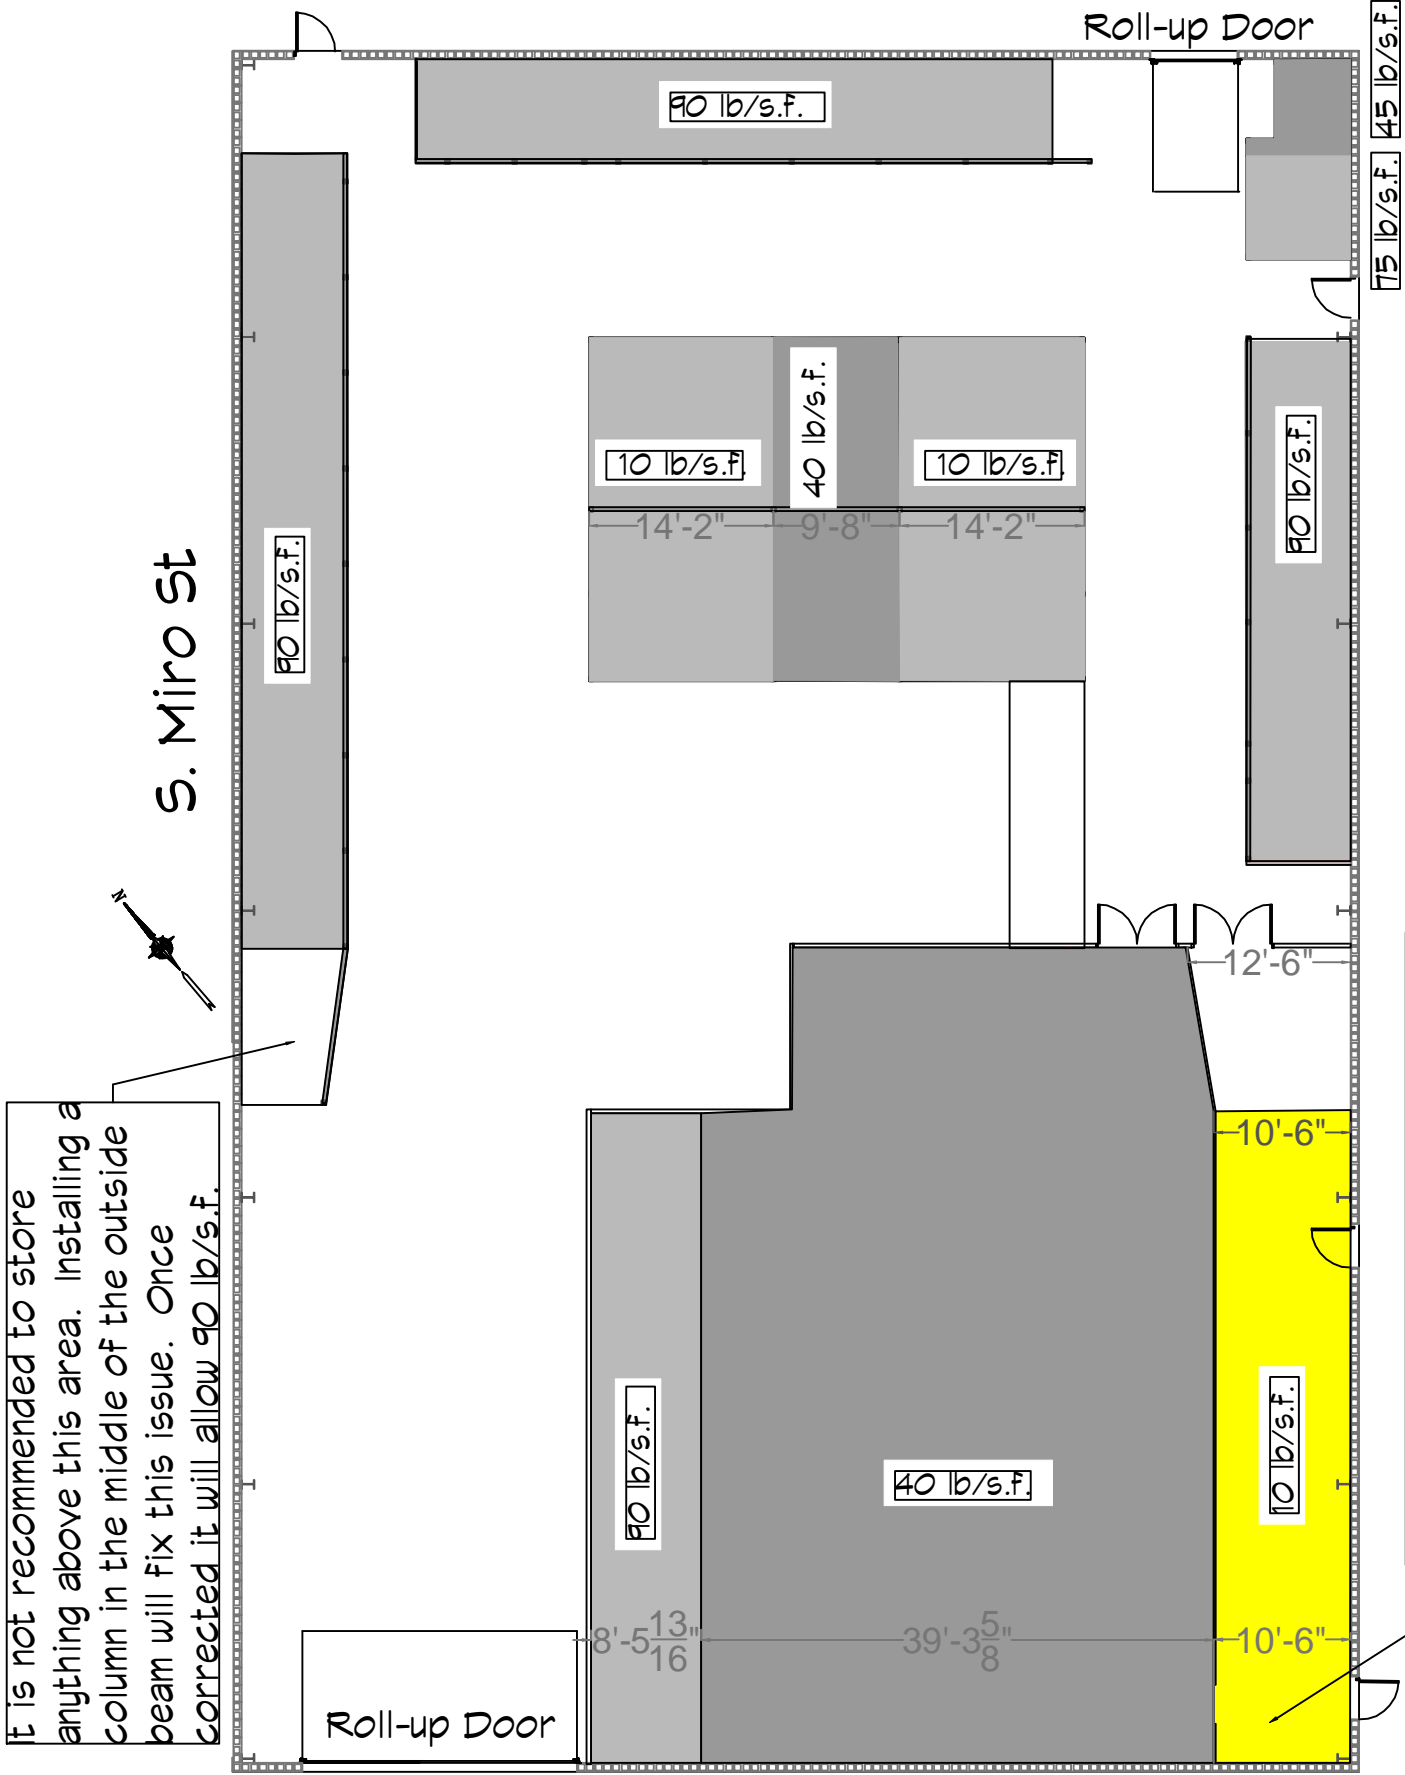
It is not recommended to store anything above this area. Installing a column in the middle of the outside beam will fix this issue. Once corrected it will allow 90 lb/s.f.

This area is limited because of the connection to the CMU wall. If fixed the allowable weight will increase to 75 lb/s.f.
